GenCost 2020-21:

Consultation draft  
feedback

March 2021

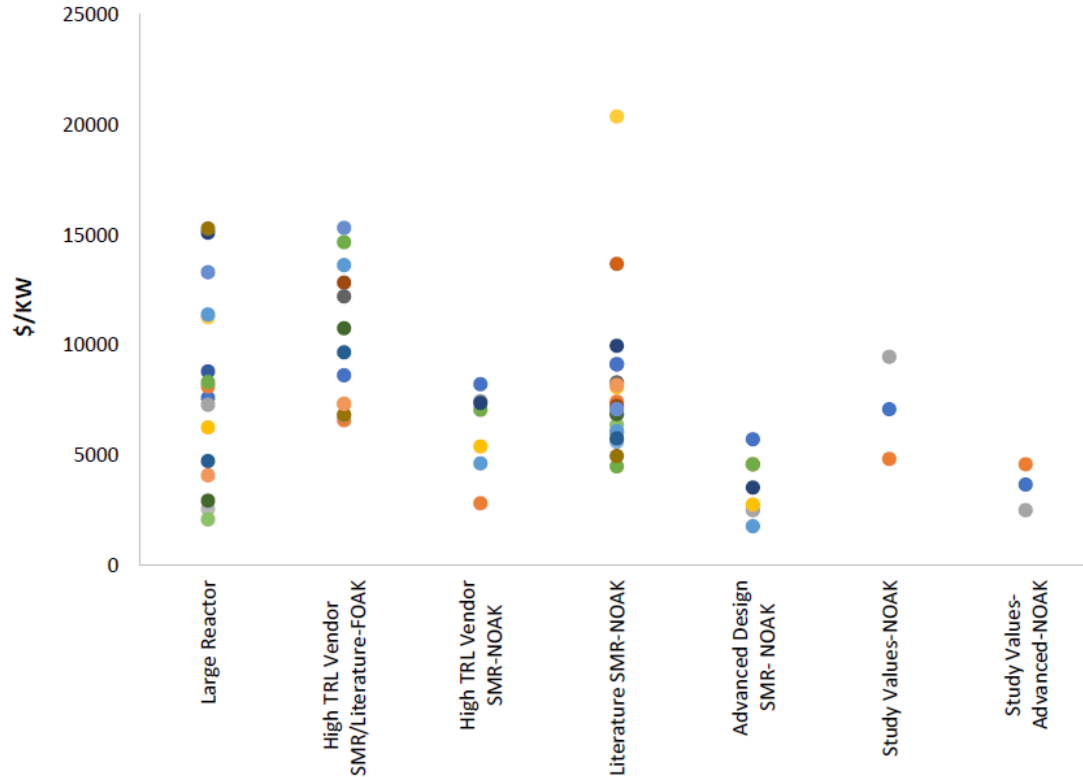
- **GHD 2018:** 100% higher than conventional nuclear. Source not well-documented. Appears to be IEA /Nuclear Energy Association *Projected costs of electricity generation 2015* which was reproduced on the World Nuclear Association website.

two SMR-based plants are under construction, one in Argentina (CAREM reactor) and one in Russia (KLT-40s, a floating power plant). Because of their size, the specific per-MW costs of SMRs are likely to be higher (typically 50% to 100% higher per kWe for a single SMR plant) than those of large generation III reactors. However, economies of volume could compensate economies of scale if a sufficiently large number of identical SMR designs are built and replicated in factory assembly workshops. Lower

- $2 \times \$US5,600/kW \div 0.7 = \$A16,000/kW$

Current Lazard's cost range conventional nuclear: US\$6,025-US\$9,800/kW  
Take mid-point, 50% premium and 0.75 A\$/US\$= \$15,825/kW

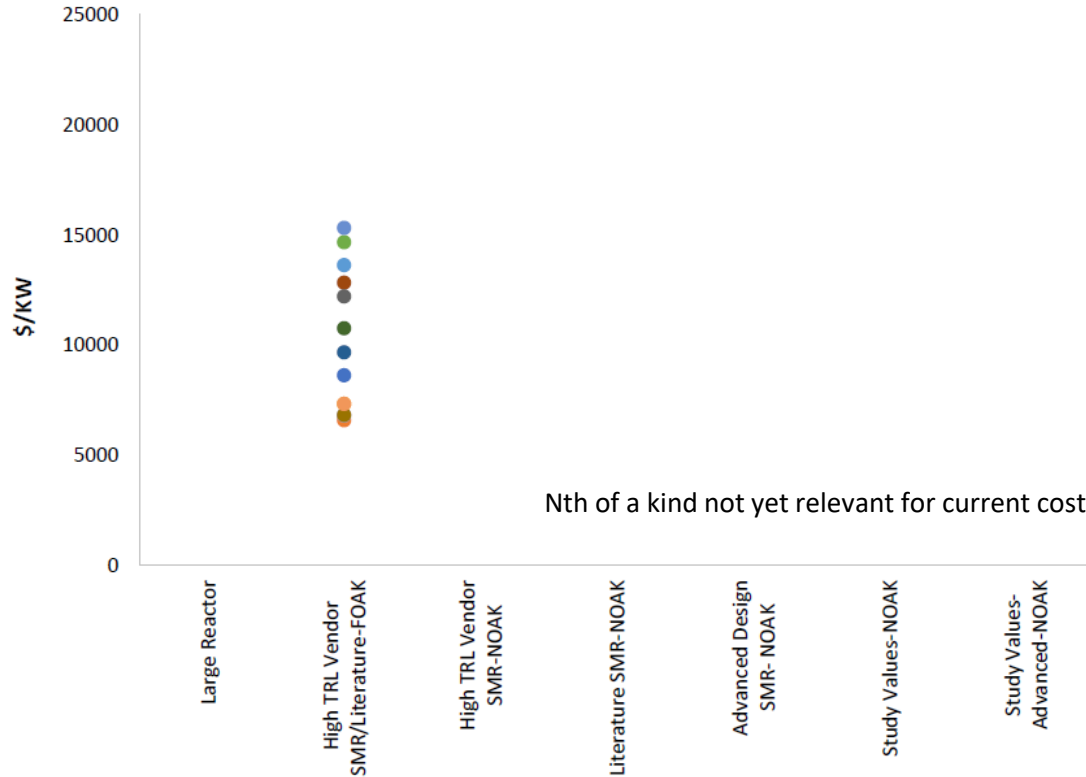
Stakeholders advised this data source is preferable to GHD's estimate

We did consider this source in 2019

Range is C\$6,593 to C\$15,333

In 2019 this converted to:  
A\$7,245 to A\$ 16,849

In this context GHD's estimate remained reasonable

Given Australia's lack of experience in deploying nuclear, it seems unlikely our FOAK would be at the lower end of the range.
